G.1.a.k 1737 Rockland Avenue: Update Report for Rezoning Application No. 00755 and Development Permit with Variances Application No. 00226 (Rockland)

To: Committee of the Whole **Date:** June 15, 2023
From: Karen Hoesel, Director, Sustainable Planning and Community Development
Subject: **Updated Report for Rezoning Application No. 00755 and Development Permit with Variances Application No. 00226 for 1737 Rockland Avenue**

East Neighbour

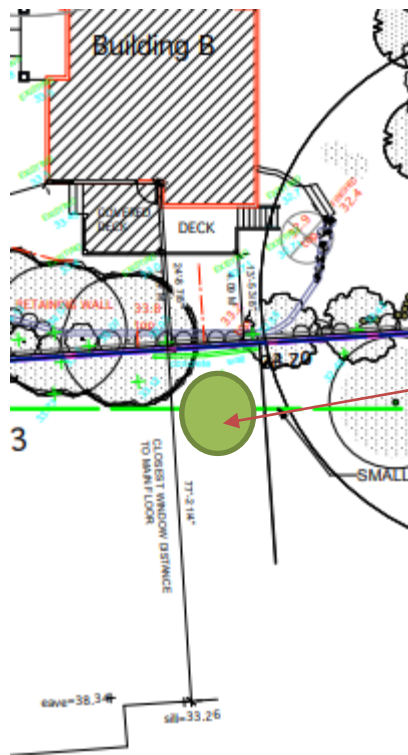
Notably, the east elevation faces the side yard of our neighbour, and more specifically is adjacent a side where there are very few windows. In addition to the increased setback the neighbour's rear yard and recreation area is further obscured by a large tree on their property.

- The east elevation does not face our garage – this is factually inaccurate. It faces our master bedroom windows, our master bathroom window, and side yard.
- The tree the applicant references does not obscure all of our rear yard. It is located in the south east corner and, while it does provide some privacy, the entirety of our side yard would still be visible from a two-storey home.

To bring the application closer to policy, Building B design was significantly modified to allow the south setback to now be 7.5m (to a habitable window). The actual distance between the buildings is 23.5m, or 19.4m from the deck.

Tree planted for additional privacy on neighbour's property

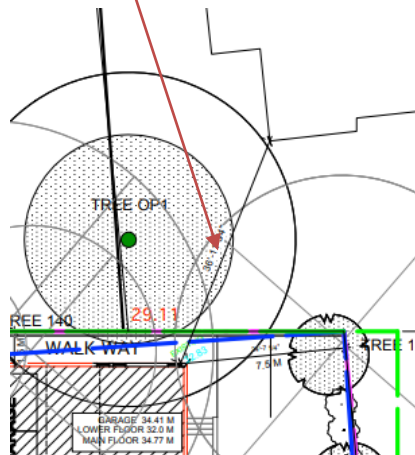
The north set back is 1.5m, which is the typical interior side yard setback. Note the actual distance between buildings being 11.3m.
